STAFF REPORT  
KETCHUM PLANNING AND ZONING COMMISSION  
MEETING OF MAY 14, 2024

**PROJECT:** Herbie’s Launching Pad

**FILE NUMBER:** P24-010

**APPLICATION TYPE:** Pre-Application Mountain Overlay Design Review

Figure 2: Comprehensive Plan Future Land Use Map

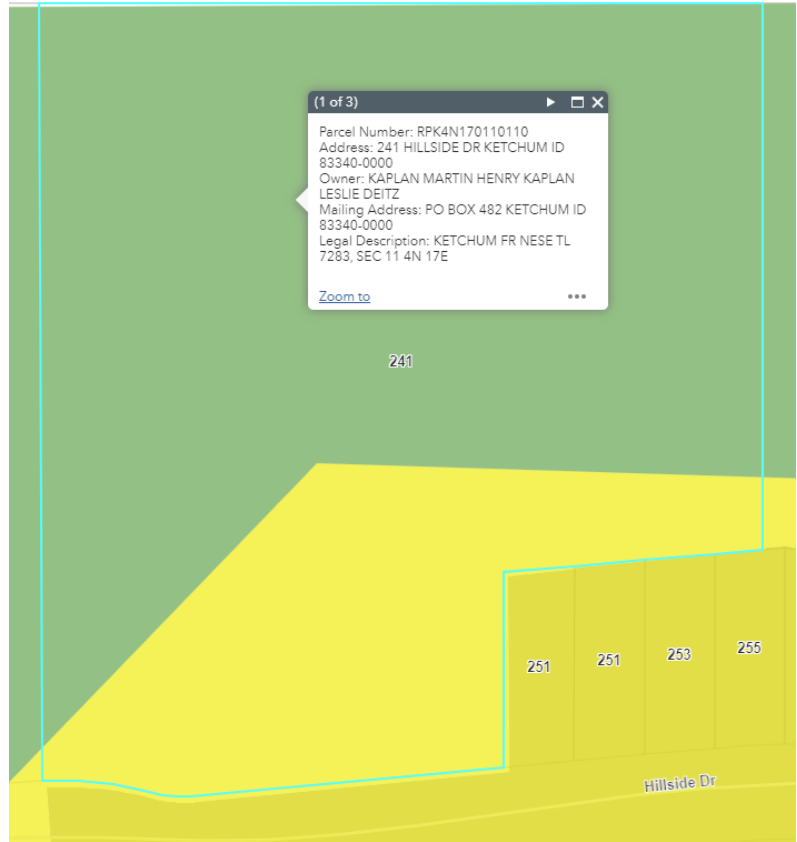
The 2014 Comprehensive Plan's future land use map identifies two different future land use designations for the subject property, the lower and upper portions as represented in green and yellow in Figure 2. The map designates the future land use for the downhill portion of the subject property in yellow as low-density residential. Desired primary uses within this future land use category include single-family and duplex residences as well as accessory units. The proposed single-family residence falls within the primary uses of the low-density residential land use category. Open space is identified as an appropriate secondary use that complements the low-density residential units. The uphill portion of the subject property in green is designated as open space, parks & recreation which does not encourage any development in that area of the property.

**GRADING PLAN  
 DRAINAGE PLAN**

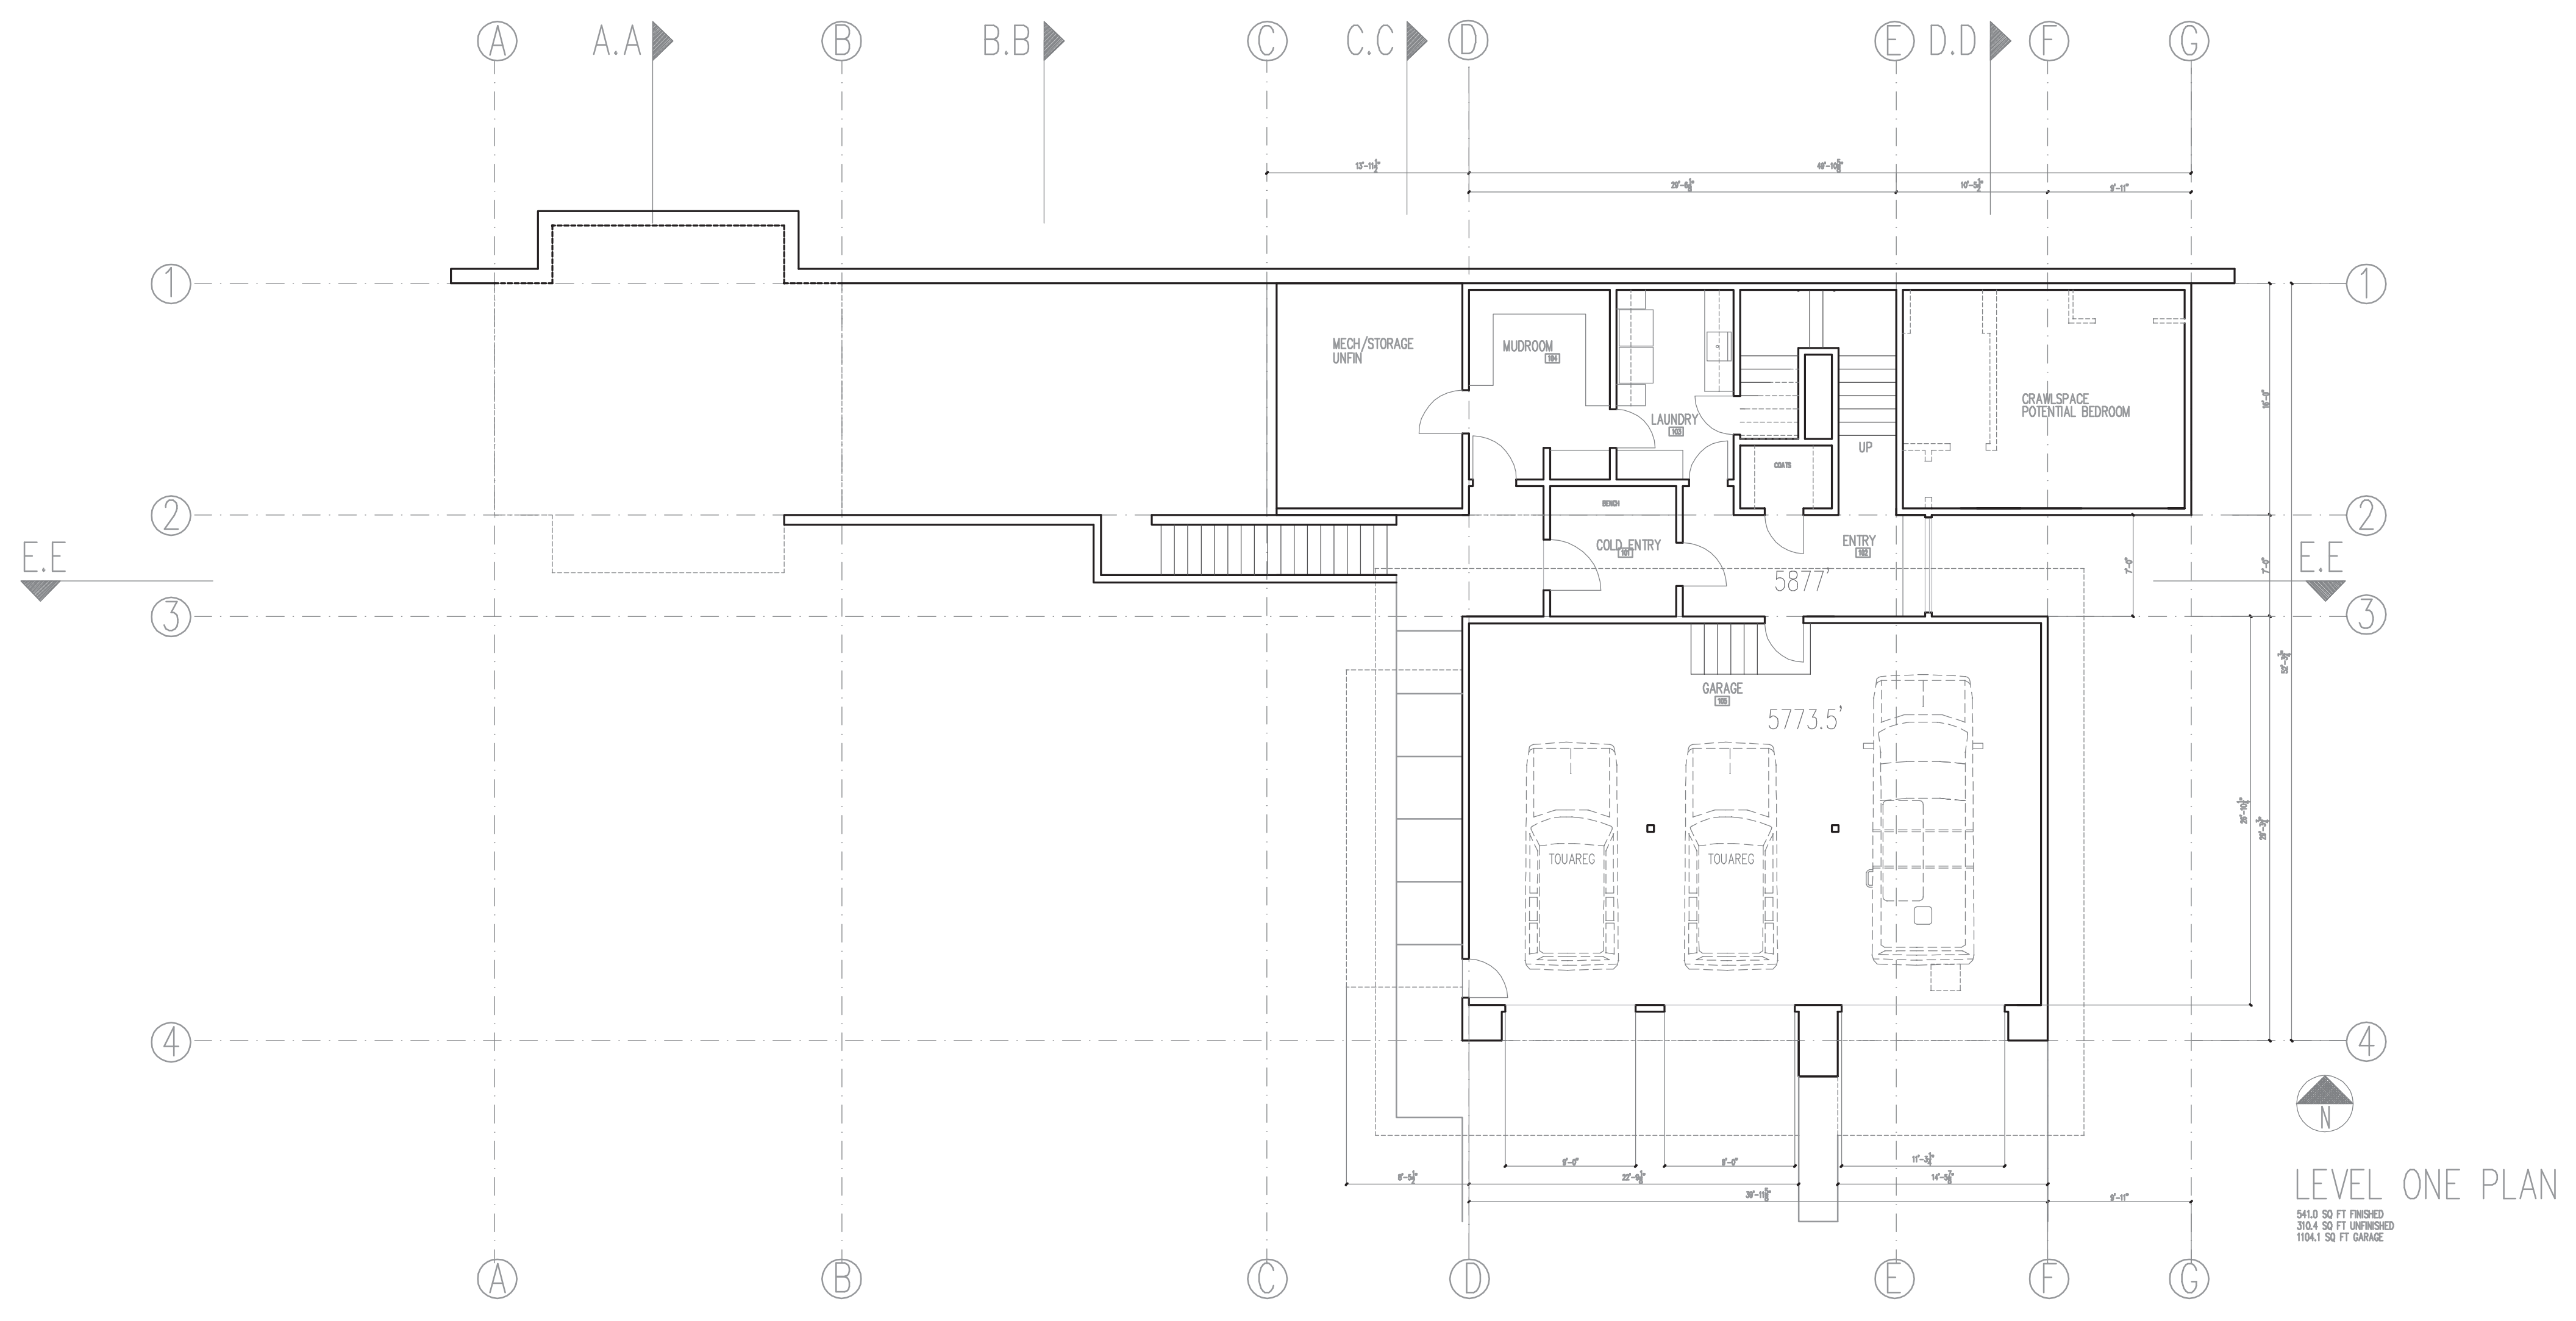
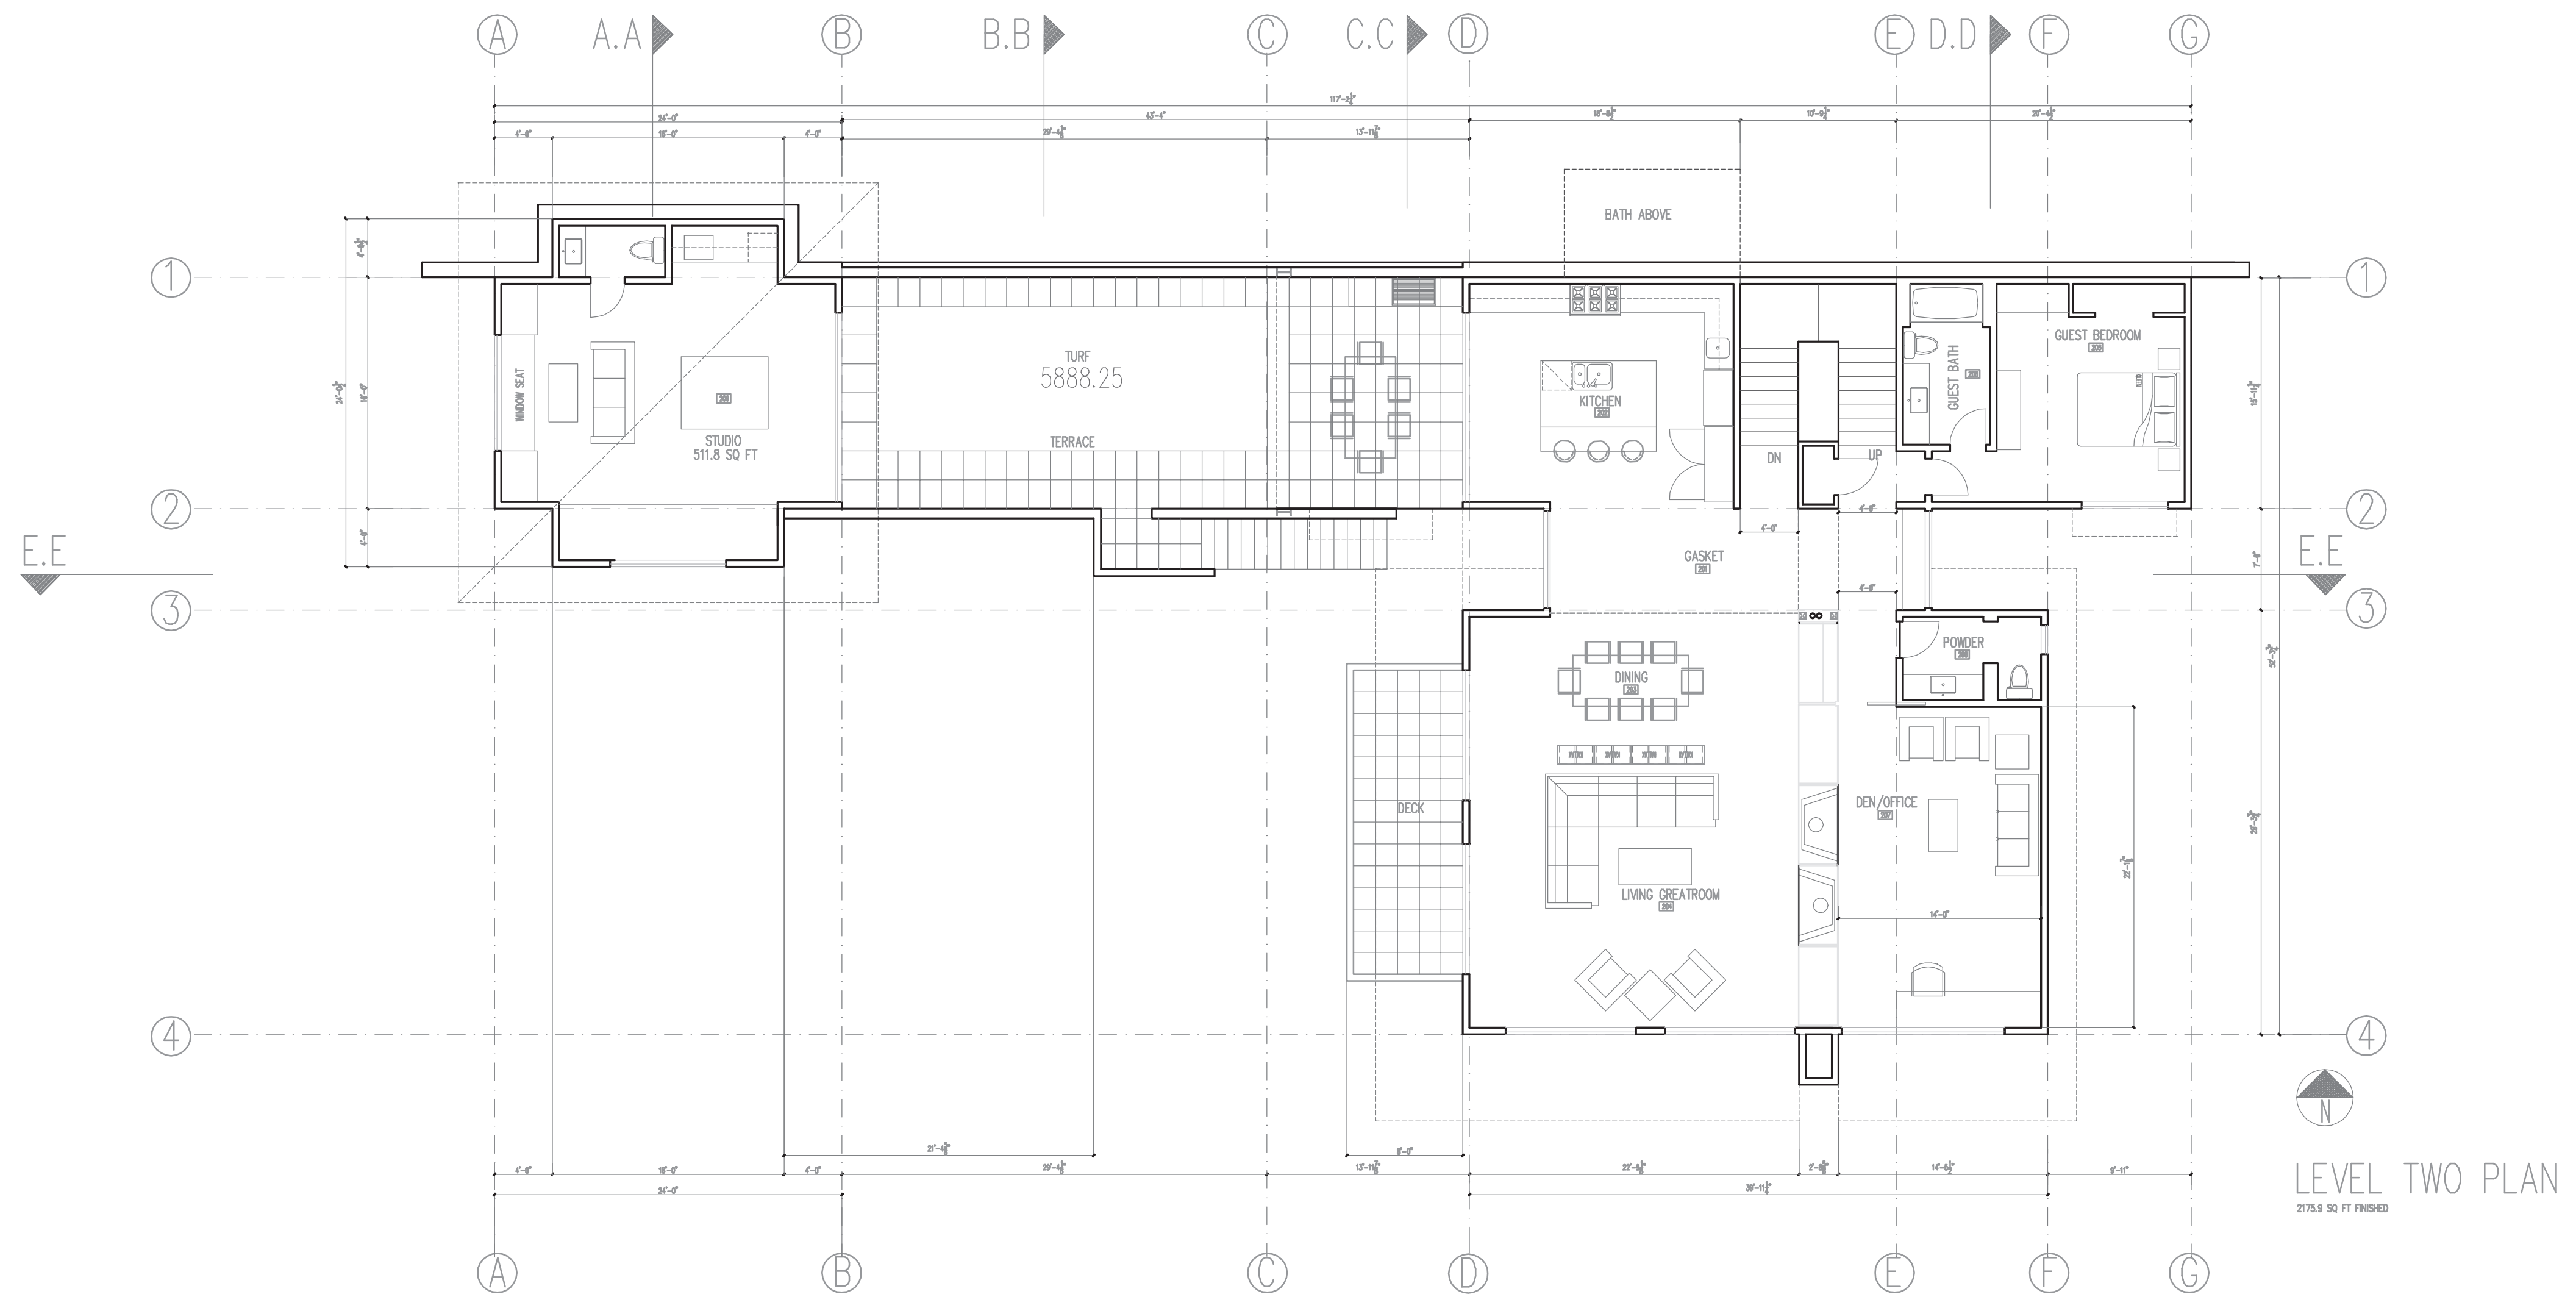
- Driveway – During the first round of comments, staff encouraged the applicant to re-evaluate the driveway layout, as the angled approach disturbed the hillside to a greater extent than a straight driveway approach would. Additionally, staff recommended reconsidering the motor court area, as it would require a significant amount of grading into the hillside. The applicant redesigned the driveway to a straight approach and removed the motor court area. Staff acknowledges that these modifications did reduce hillside disturbance; however, the driveway could use continued refinement to minimize its length. One significant factor influencing the length of the driveway is the development’s placement, which has a front yard setback of 38’-10 7/8” (15’ minimum required). As shown in Figure 3 below (Sheet A.3 of Attachment A), the development is manipulating the entire hillside below elevation line 5885 to accommodate the driveway, residence, studio, and terrace and turf area. By siting the residence at a lower elevation on the site, there is a significant amount of hillside disturbance that could be avoided.

- Terrace and Turf Area – The redesign continues to feature a terrace and turf area between the primary residence and detached studio. The location of this area staff finds to be problematic as it will require altering the hillside to accommodate a lawn area. Lawns are generally not a common feature of properties in the MOD because they require disturbance to a hillside that is outside of the building construction. Also, it is unclear from the project plans at this time what the height of the retaining wall will be to create this lawn area. To mitigate disturbance to the hillside outside of the building construction, the area between the residence and studio could be reduced, or alternatively, the studio could be attached to the residence.
